12 December 2018

17593

## **CAMPBELLTOWN HOSPITAL STAGE 2 – SSD 9241 REQUEST FOR ADDITIONAL INFORMATION**

**Figure 2** Site plan (as amended)

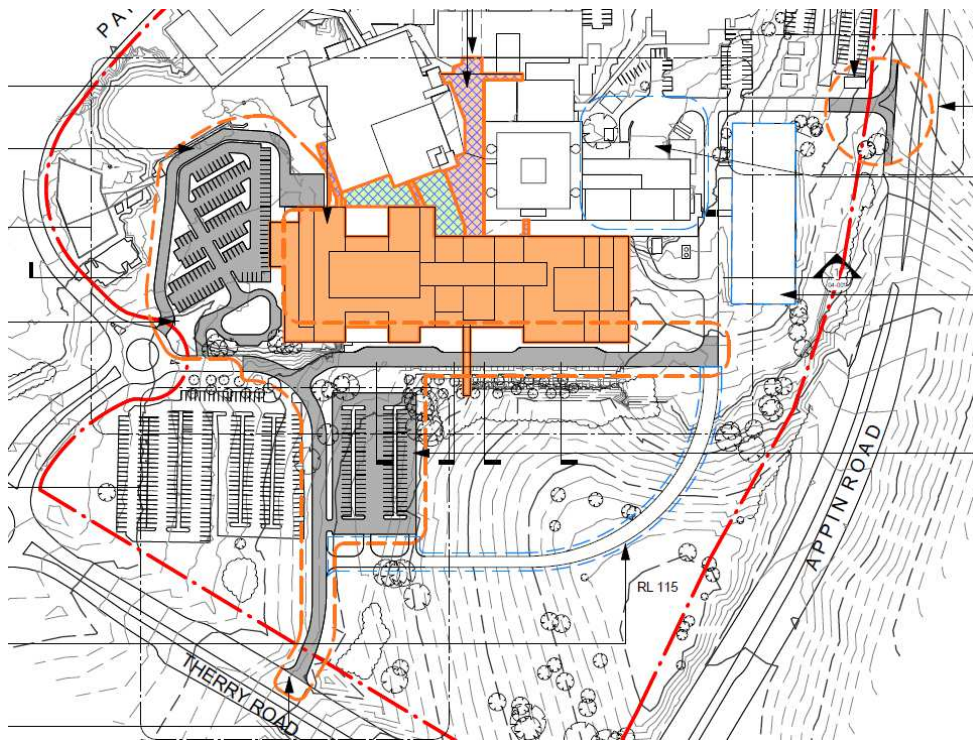
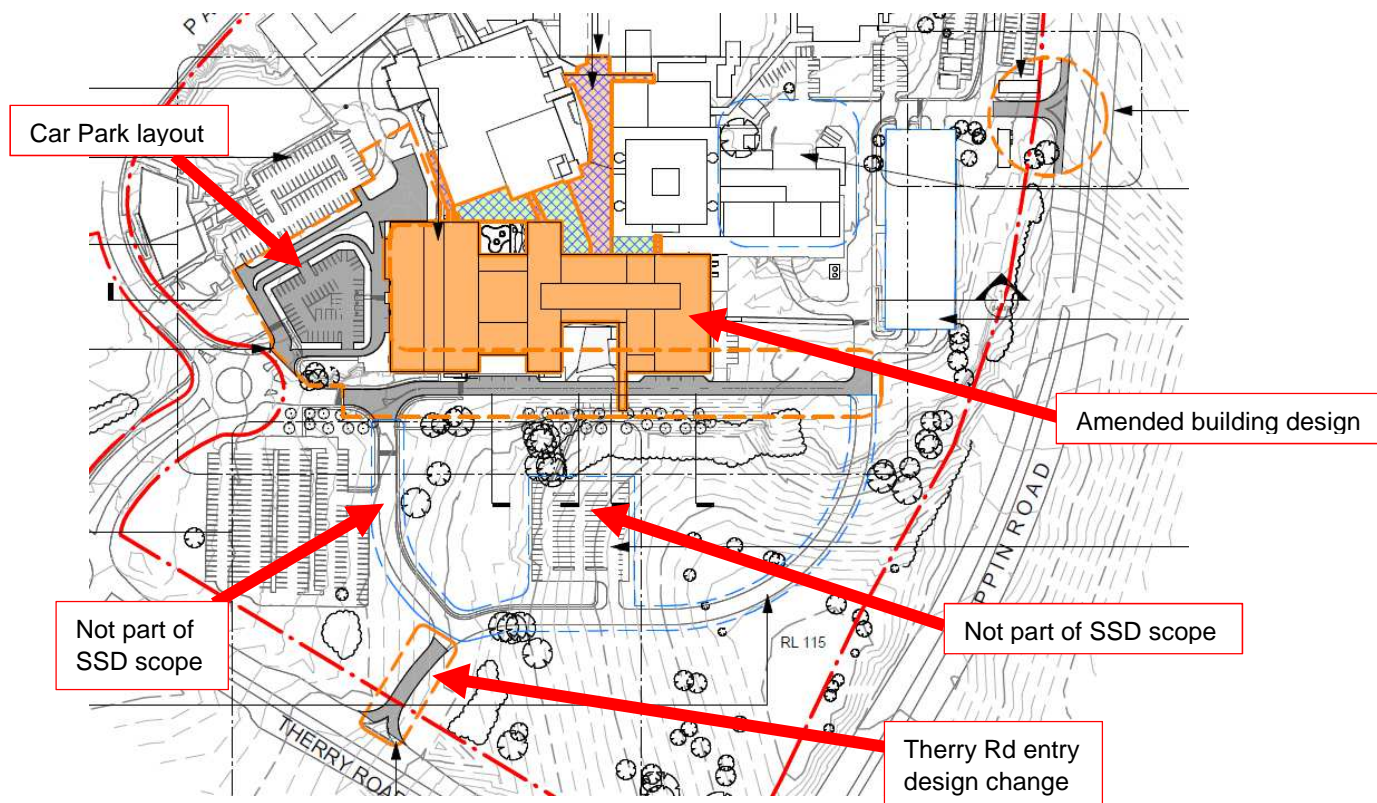
Design refinements largely reduce the extent of the SSD application with design changes reducing the extent of the building, car park and internal roads. Subsequently this results in reduced impact to vegetation. A comparison of the 'as lodged' site plan and the 'as amended' site plan is provided at **Figure 1** and **2**. The key changes include:

- Amended western car park layout;
- Removal of the internal (north-south) link road from the SSD application;
- Removal of the southern at-grade car park from the SSD application;
- Minor change to the Therry Rd entry; and
- Changes to the Hospital design as addressed in a separate submission to the Department (dated 12 November 2018).

**Figure 3** General plan of non-SSD works being delivered across the Hospital

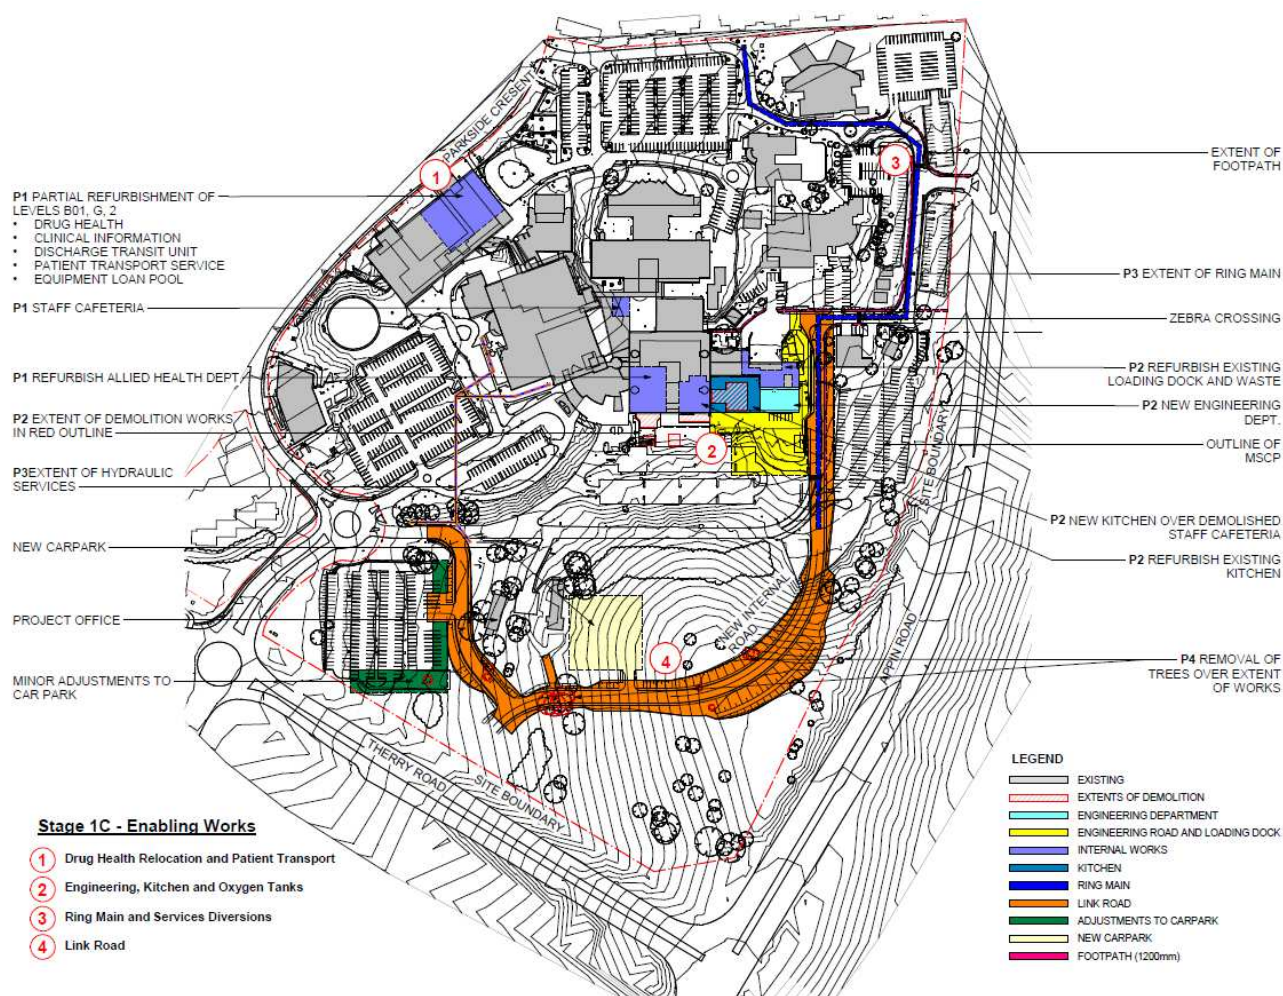
Sections 2.2.3 and 2.2.4 of the EIS describe changes to the kitchen and loading dock of Building B and a new internal link road in the south of the Hospital grounds. These works also remain unchanged and are being delivered via a separate approval under Part 5 of the EP&A Act (REF). A key change to the REF since preparing the EIS is the delivery of an at-grade car park off the new link road. The REF includes a range of other works separate to the SSD to improve Hospital facilities, services and infrastructure. The works are summarised as follows:

- Construction of a new link road;
- Modification of existing car park (CP9) (no loss or gain in parking);
- Construction of a new southern at-grade car park (94 spaces); and
- Tree removal.

A high level site plan identifying the works is appended to this letter and is reproduced at **Figure 3**.
